From: drainage <drainage@midsussex.gov.uk>
Sent: 05 May 2025 16:39:39 UTC+01:00
To: "Stefan Galyas" <Stefan.Galyas@midsussex.gov.uk>
Cc: "drainage" <drainage@midsussex.gov.uk>
Subject: 2025.05.05 Re: DM/25/0795 - Whitehouse Farm Cottage Staplefield Lane Staplefield Haywards Heath West Sussex RH17 6AU

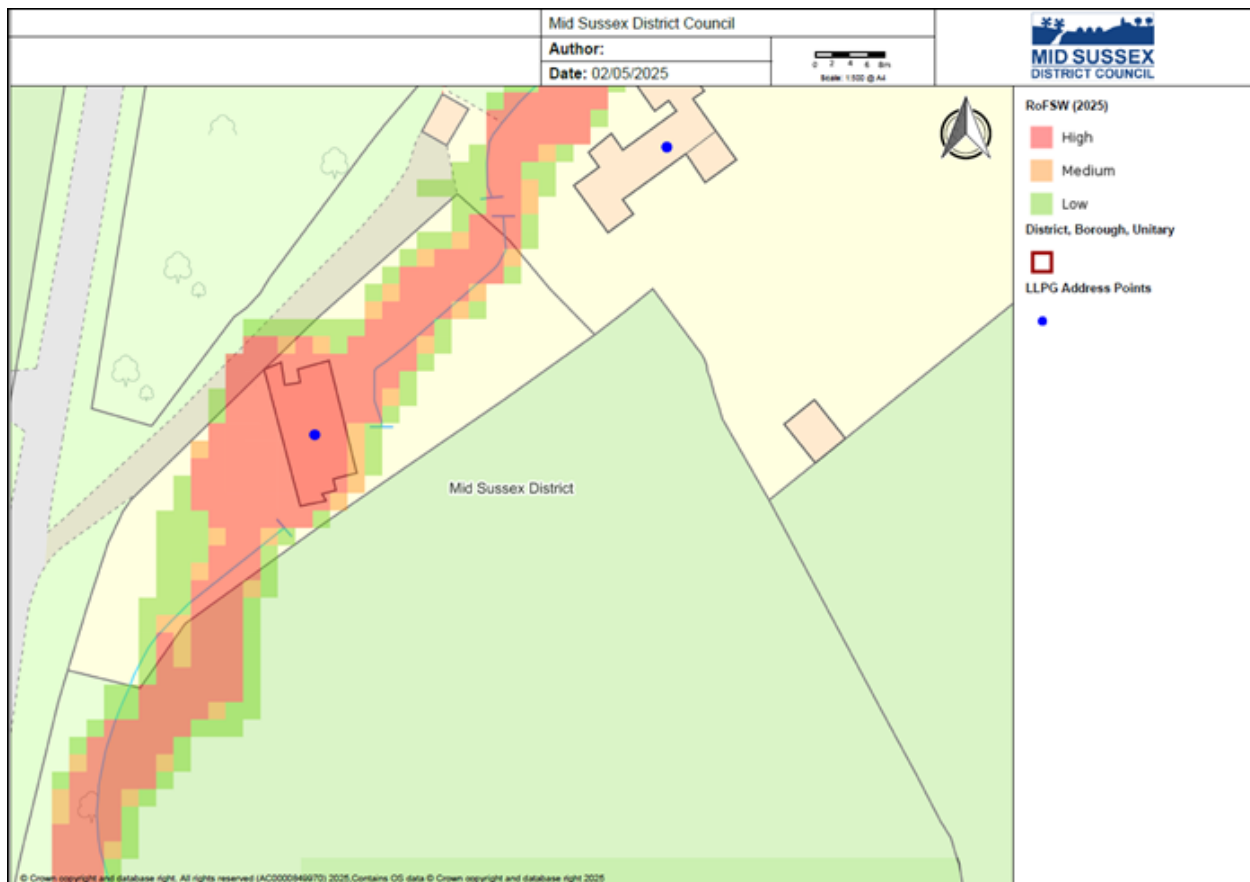
The updated Risk of Flooding from Surface Water mapping released in March 2025 shows the proposed development site is located within an area impacted by High, Medium and Low surface water flood risk. Following the approach set out under the NPPF for assessing fluvial flood risk (flood zones) this area would be considered consistent with Flood Zone 3b, 3a and 2.

As per the Environment Agency standing advice for minor extensions, development within the 1:30 (3b) flood extent is not permissible. In the event that the proposal is outside of this extent, then additional resistance and resilience mitigation will need to be evidenced at this location, as this development is classified as 'more vulnerable'.

We would advise that the applicant that an overlay of their proposed block plan on the above screenshot (or equivalent) of the 1:30 flood extent is required at this stage of planning in order for us to review any encroachment.
